Group 31 Front Fork	August 1983	Bulletin No.: 31 009 83 (2082)
------------------------	----------------	-----------------------------------

RE: FRONT FORK NOISE

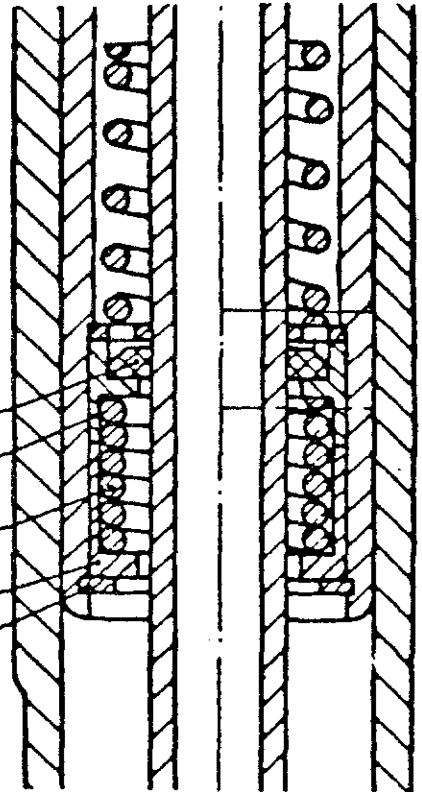
The telescopic front fork dampers on all models except R65' and R65LS now come equipped with a new spring-loaded valve housing, which eliminates axial play that may cause front fork noises.

It is no longer necessary to use shims for spacing as advised in Service Information 31 007 82 (2046). The valve washer is now provided with a chamfer that serves to cut down the noise level even further.

Note that this chamfer is always installed towards the perforated disk. Whenever repairs are performed, make sure both fork dampers are equipped with this new spring-loaded valve housing.

- Valve Disk Washer Part No. 31 42 1 242 645
- Valve Housing Part No. 31 42 2 301 885
- Spring Part No. 31 42 1 241 665
- Ring Part No. 31 42 2 301 886
- Retaining Ring Part No. 07 11 9 934 645

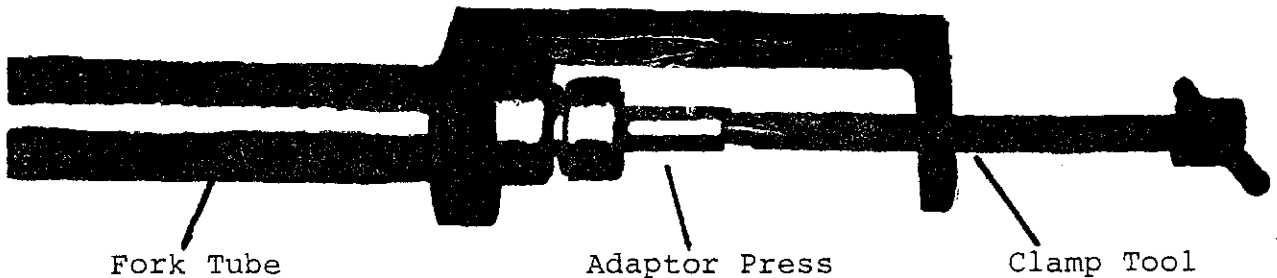
To install the two-part damper housing, use special tools No. 88 88 6 314 690 (clamp) and 88 88 6 314 693 (adaptor press). Fix the clamp and adaptor press as shown in the drawing below.

Using these tools, you will be able to compress the valve housing spring so it will be easy to install the retaining ring.
